ADDENDUM #2

Reference: Greendale Maintenance Station Replacement
Utah Department of Transportation – Daggett County, Utah
DFCM Project No. 07029900

Subject: **Addendum No. 2**

2.4.1 The complete **drawing set has been revised and is re-issued with this Addendum.** Owner requested the deletion of the mezzanine and mezzanine access. Walls around office area extend 18'-0" A.F.F. Building footprint has been revised to incorporate larger truck bays. All drawings for all disciplines have been revised showing new building footprint & layout.

A1 FLOOR PLAN

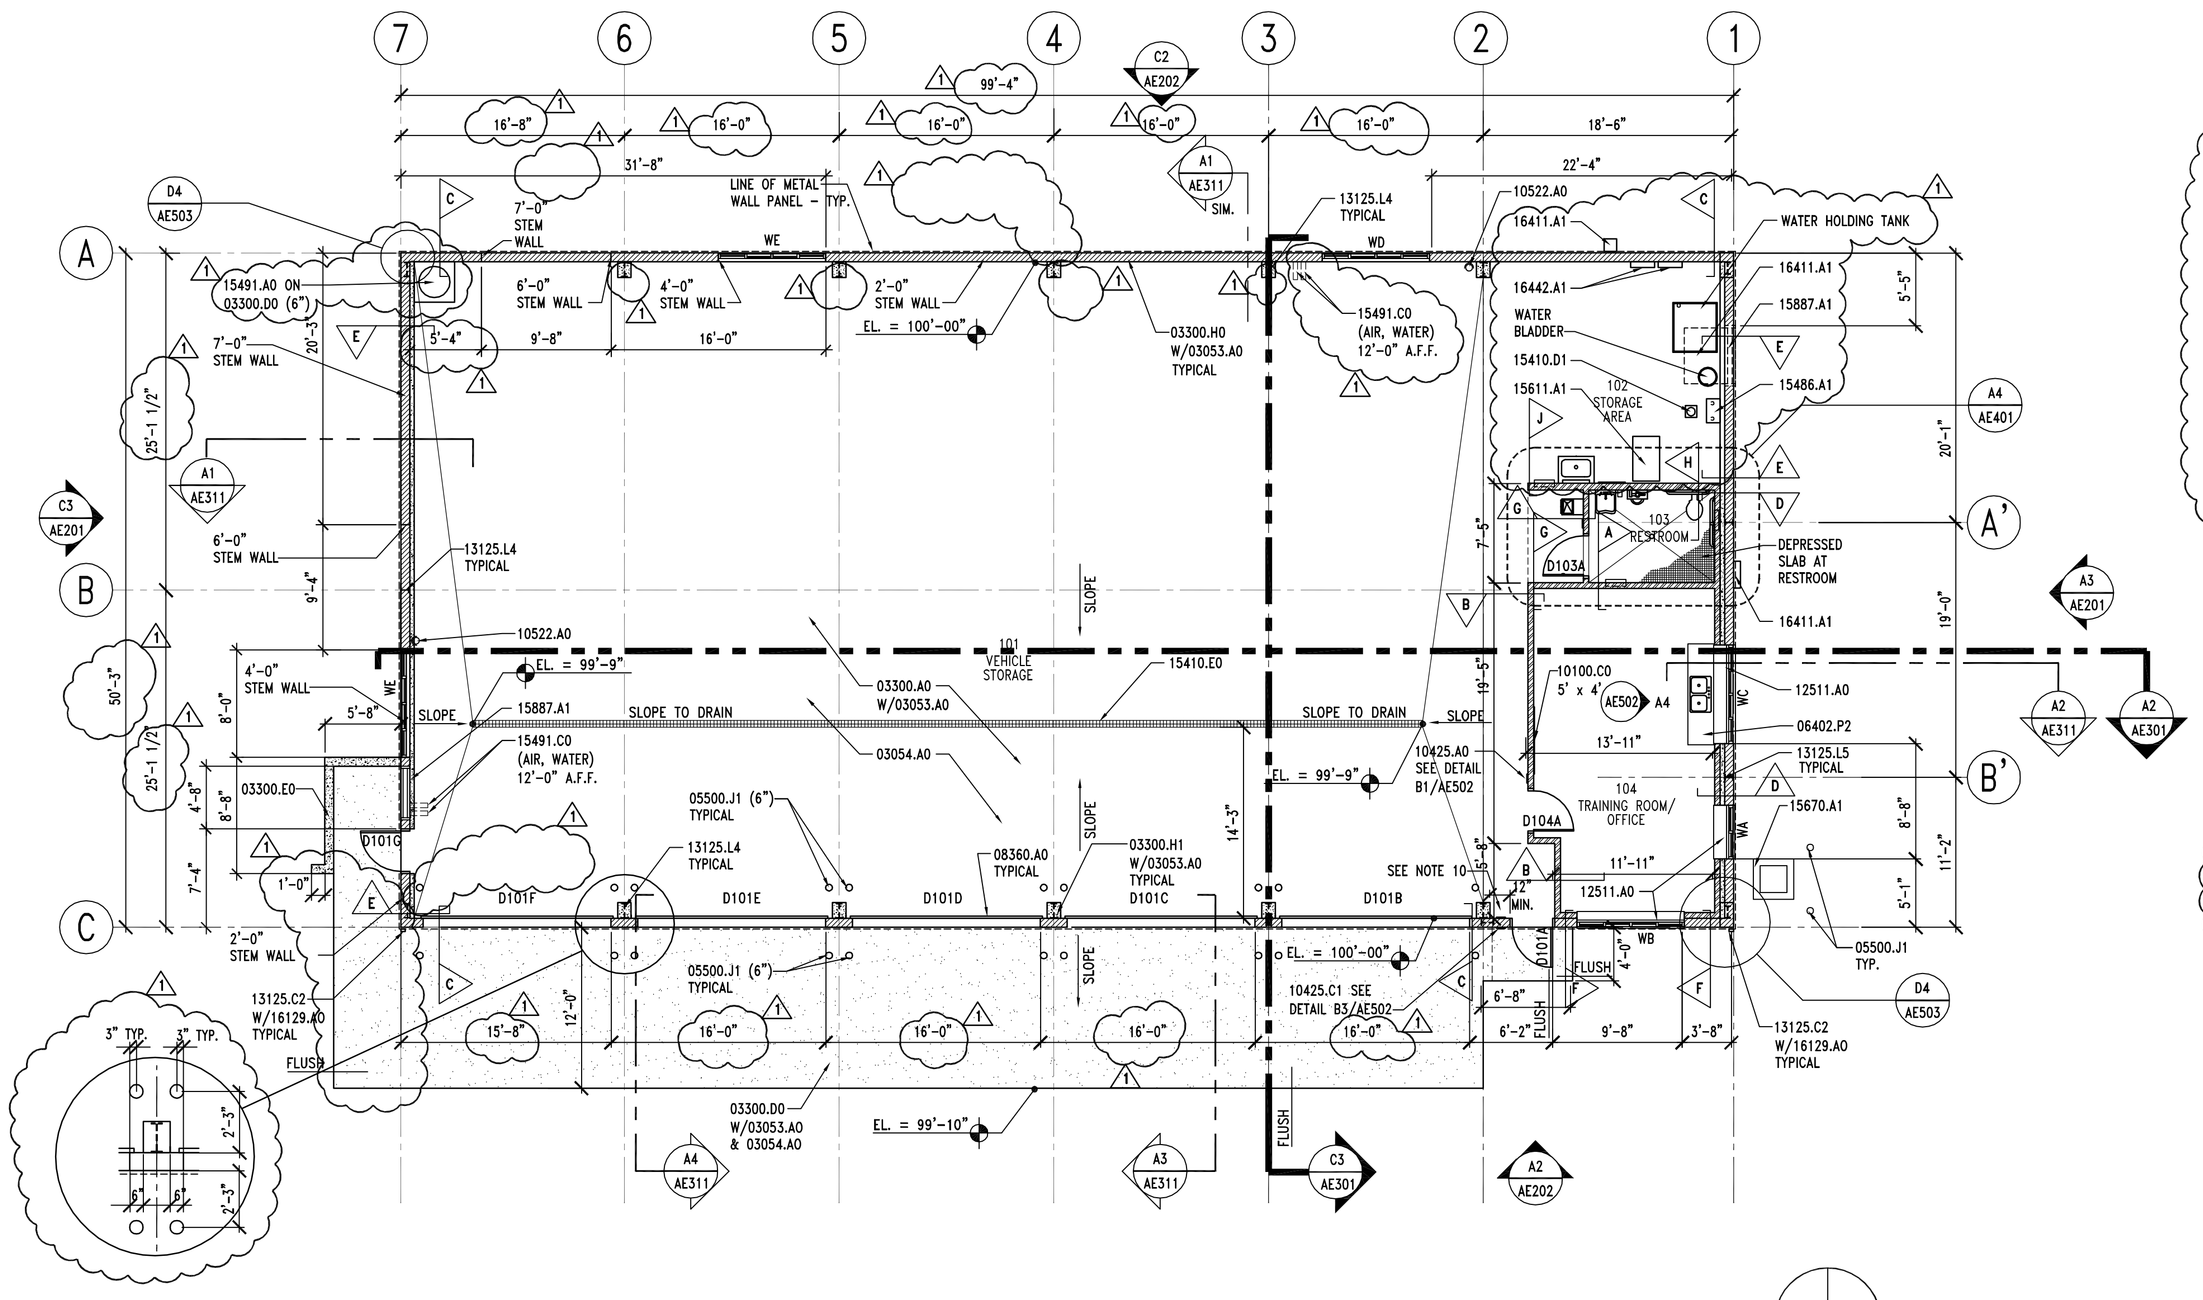
a. Added additional air & water hose reel.
b. Added compressor & pad near grid 7A.
c. Revised storage area layout
d. Revised building dimensions.
e. Increased size of concrete apron @ grid 7C
f. Deleted Mezzanine Plan
g. Deleted. Stair
h. Deleted Pipe bollards along grid A.

A2 | REFLECTED CEILING PLAN
AE121 | REF. | SCALE: 1/8" = 1'-0"

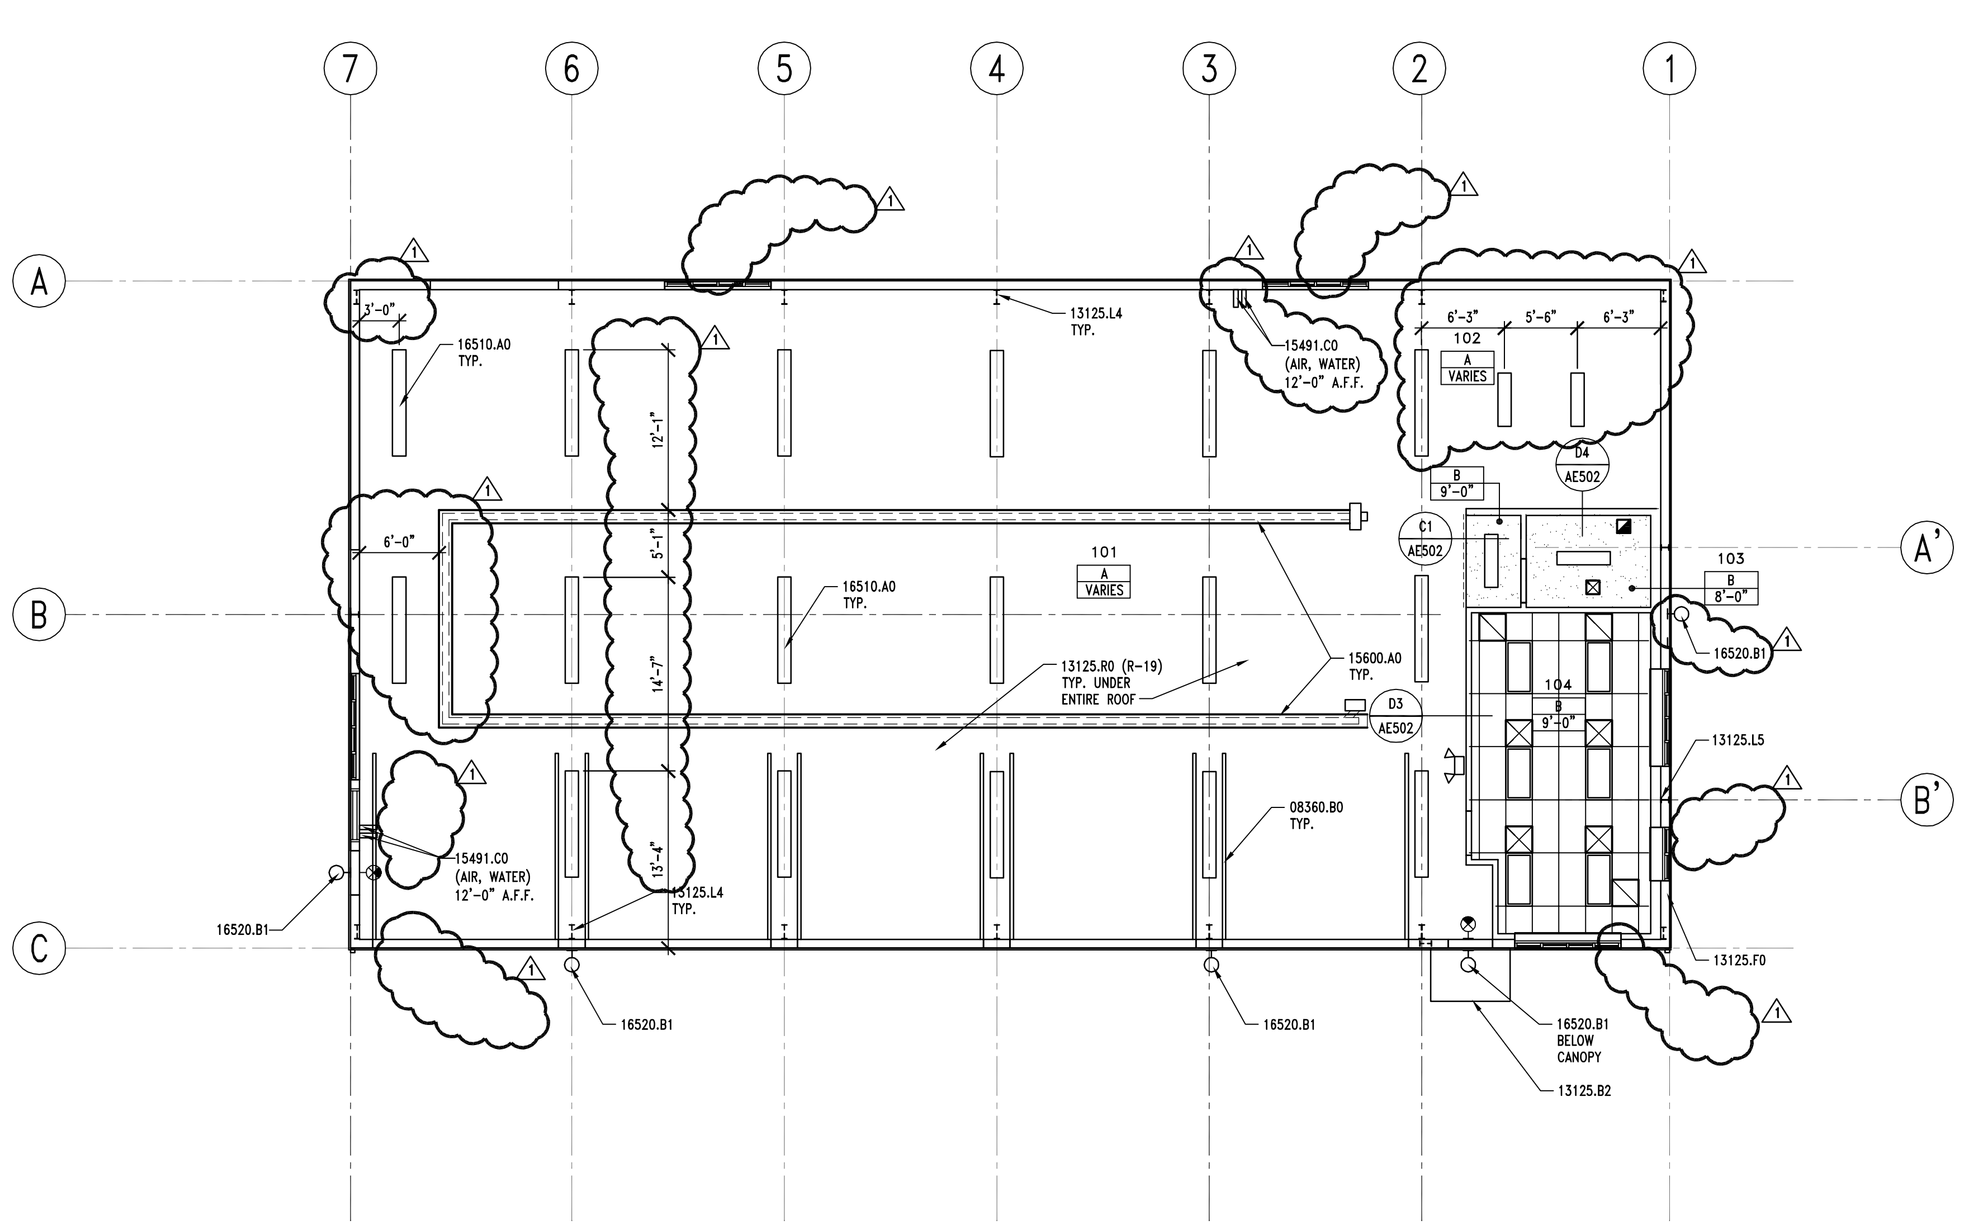
a. Added dimensions to locate all light fixtures.
b. Added additional air & water hose reel.
c. Revised light layout in storage area.
d. Revised exterior light fixture layout.
e. Delete light fixture near grid 7C.
f. Deleted Mezzanine Plan

A2 | ROOF PLAN
AS102 | REF.
SCALE: 1/8" = 1'-0"

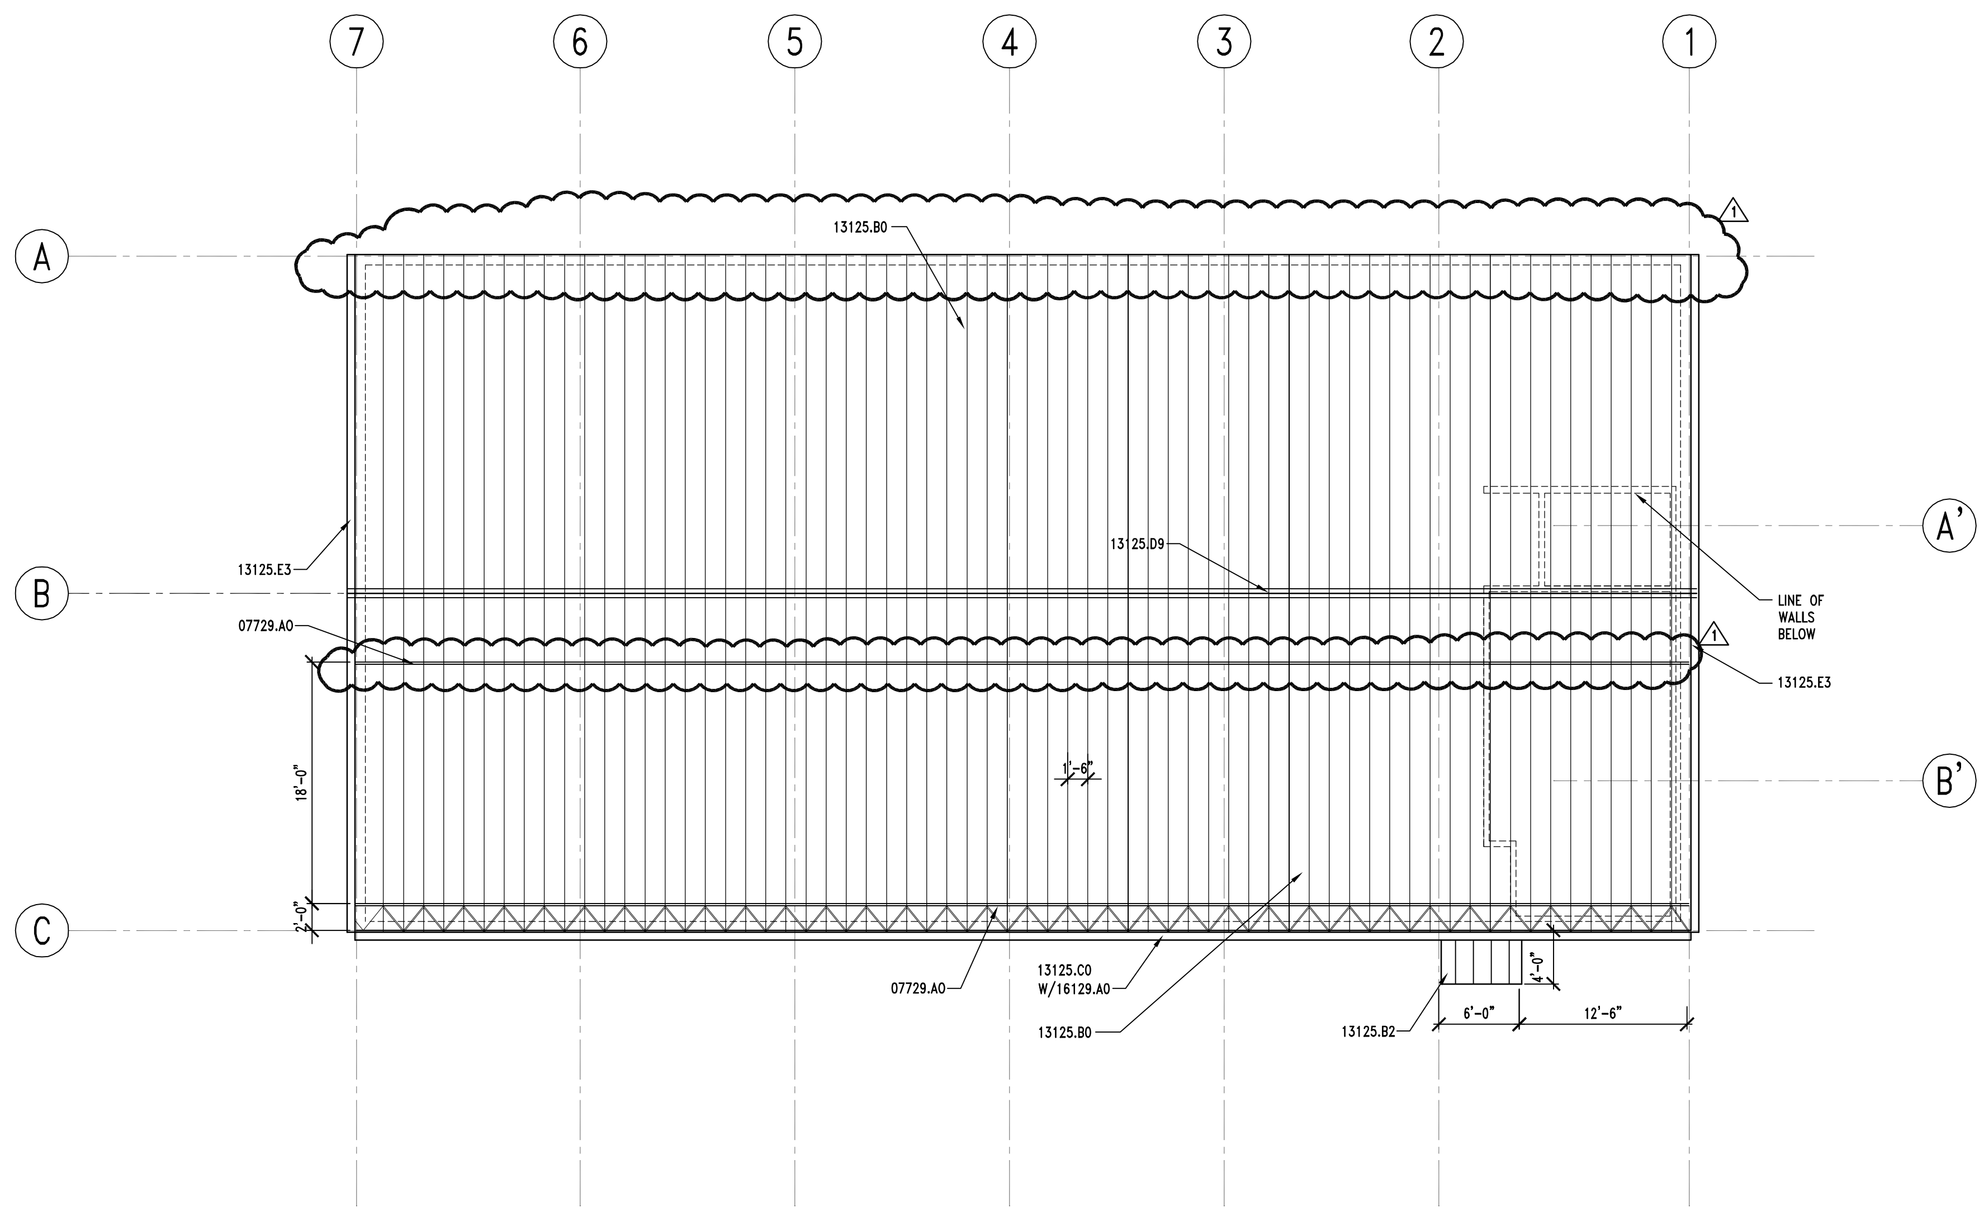
a. Added second row of Snowguard system.
b. Deleted rain gutter, downspouts & snow guard at back of building only.

AE201

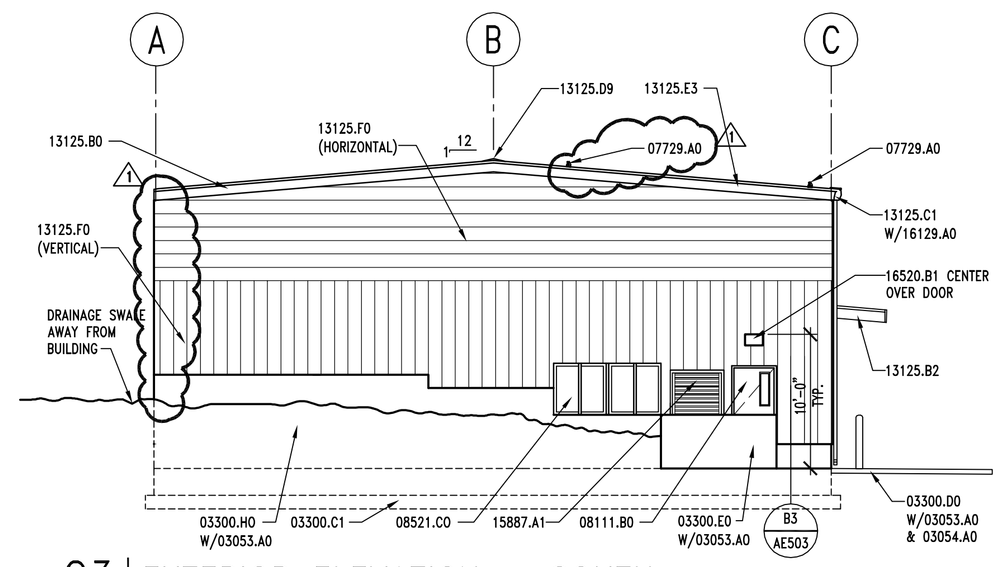
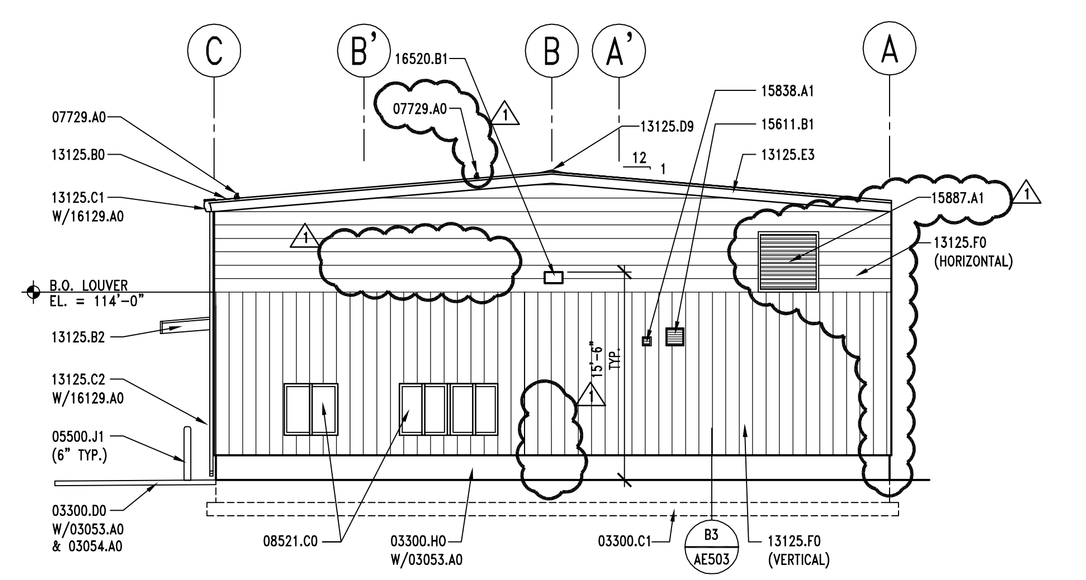
a. Added second row of Snowguard system.
b. Revised exterior light fixture layout.
c. Relocated upper Exhaust fan/louver.
d. Relocated Emergency disconnect.
e. Deleted rain gutter, downspouts & snow guard at back of building only.
f. Deleted Upper mezzanine window.

AE202

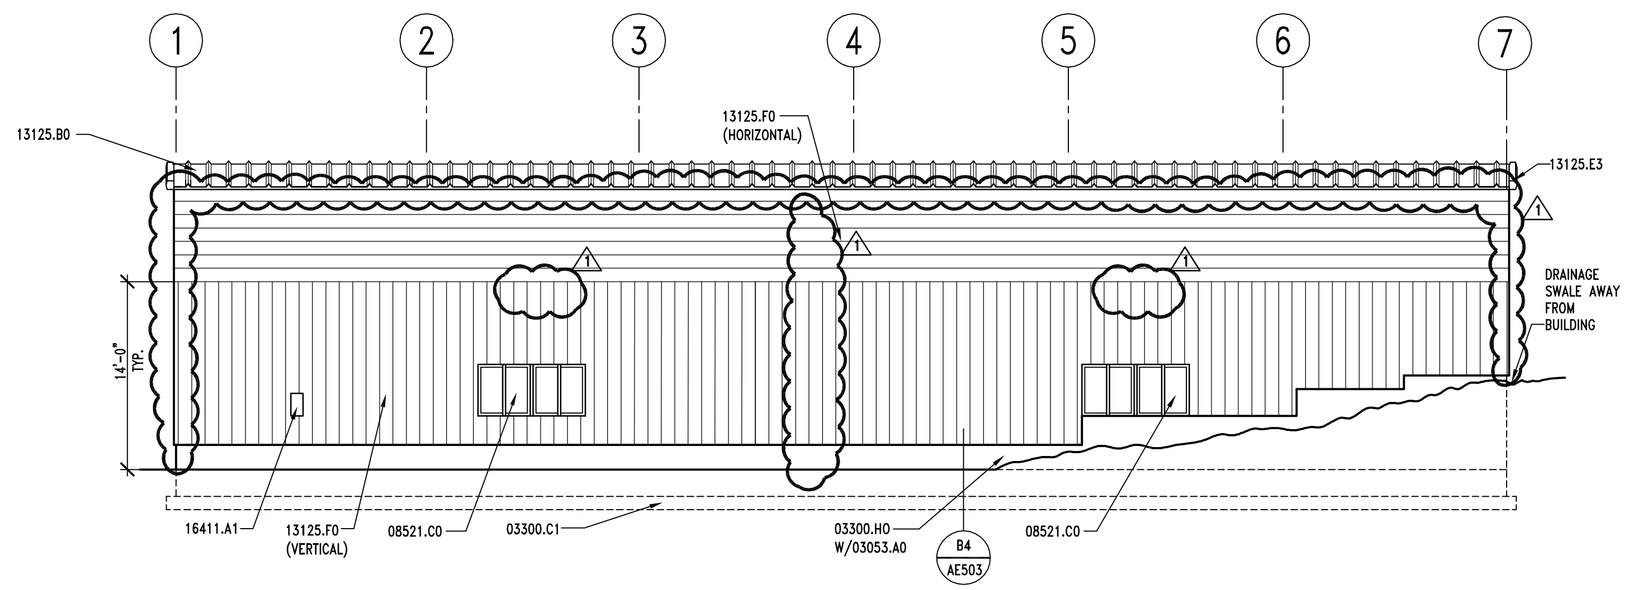
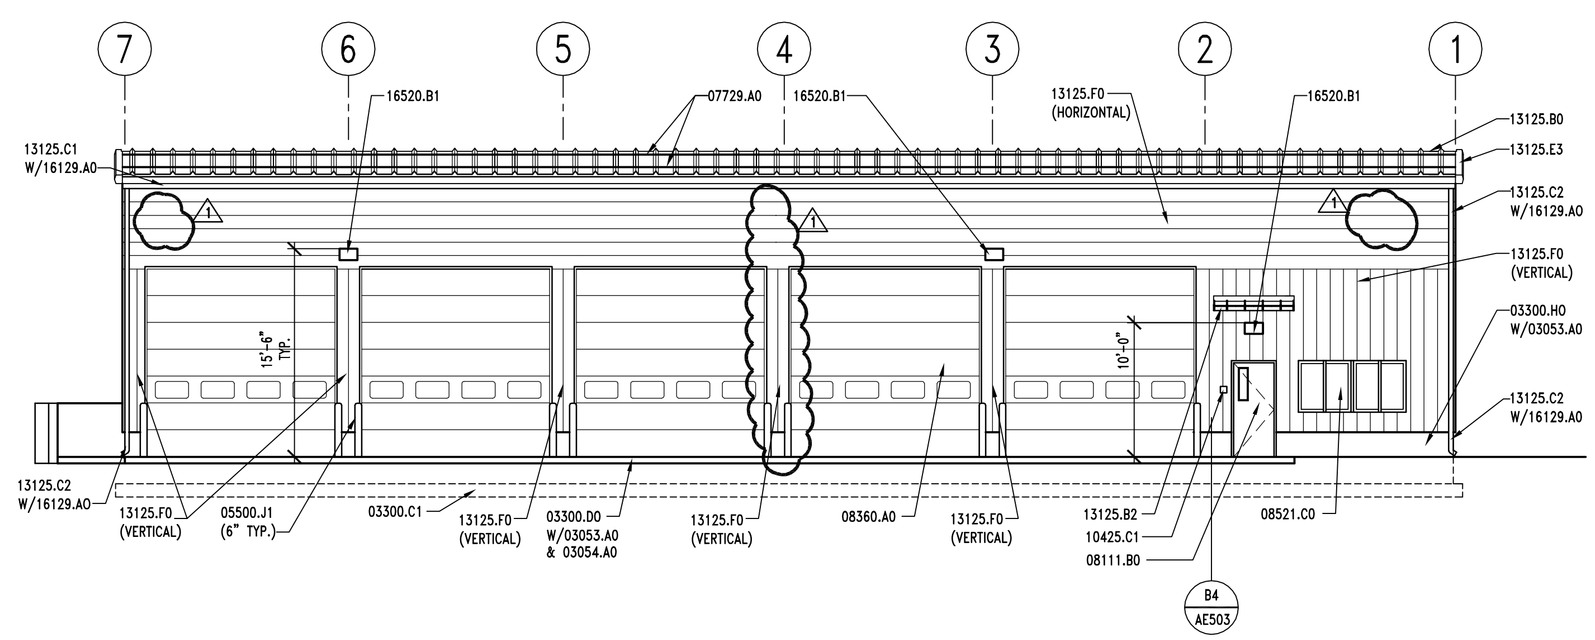
a. Added second row of Snowguard system.
b. Revised exterior light fixture layout.
c. Relocated Emergency disconnect.
d. Deleted rain gutter, downspouts & snow guard at back of building only.
e. Deleted center downspout at East elevation.
